TECHNICAL EVALUATION REPORT

REVIEW OF LICENSEES' RESOLUTION OF OUTSTANDING ISSUES FROM NRC EQUIPMENT ENVIRONMENTAL QUALIFICATION SAFETY EVALUATION REPORTS (F-11 and B-6)

INDIANA AND MICHIGAN ELECTRIC COMPANY
DONALD C. COOK NUCLEAR PLANT UNIT 1

NRC DOCKET NO. 50-315

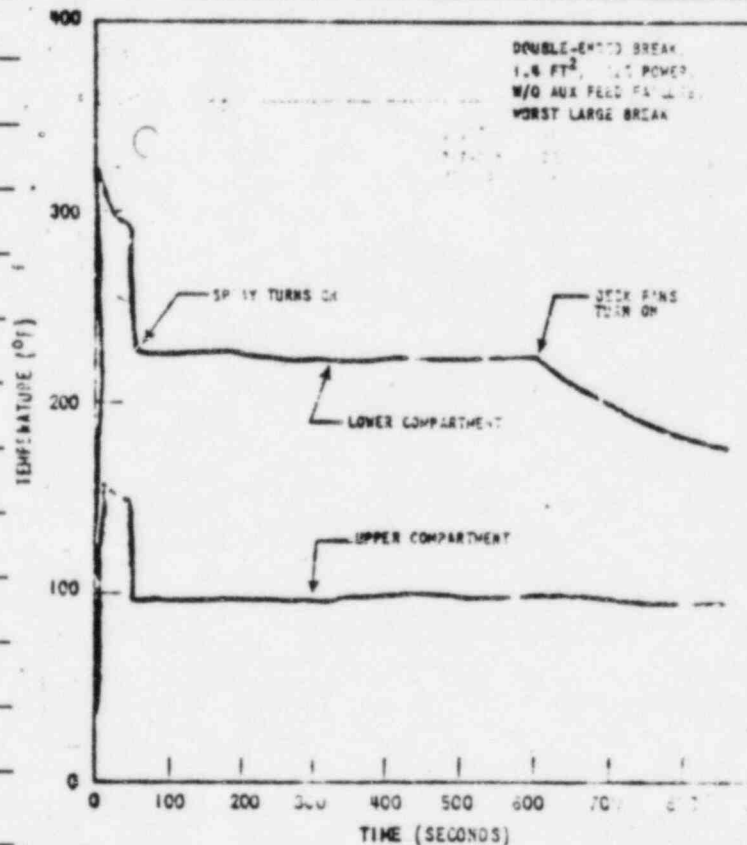
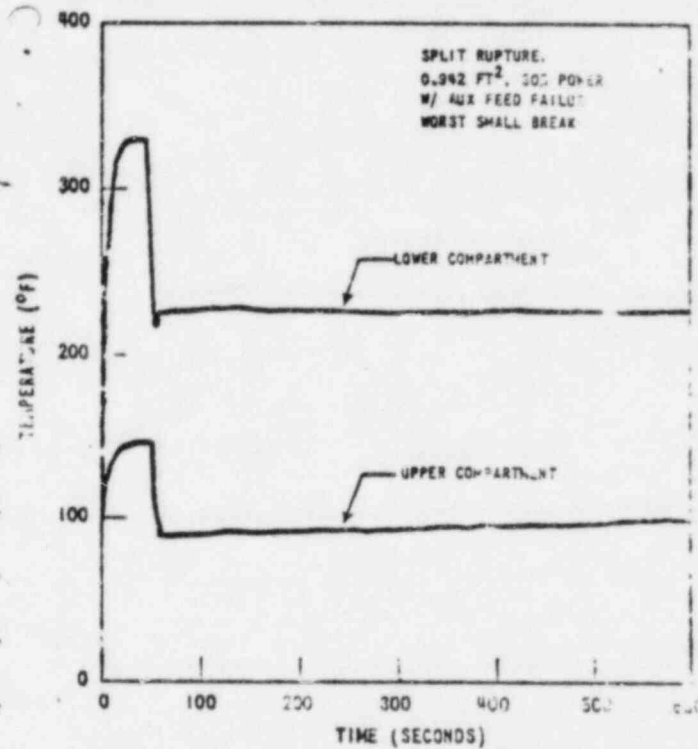
Note 2 - Table 6.1 of the test report [3829] identifies the equipment which passed the test and equipment which did not. This table is reproduced on page 5j.

The test profile envelopes the MSLB curves on p 5g but not the LOCT profile shown on page 5h. The SCRW sheet indicates that the required operating time is 24 hours. Therefore the test envelope the required operating time
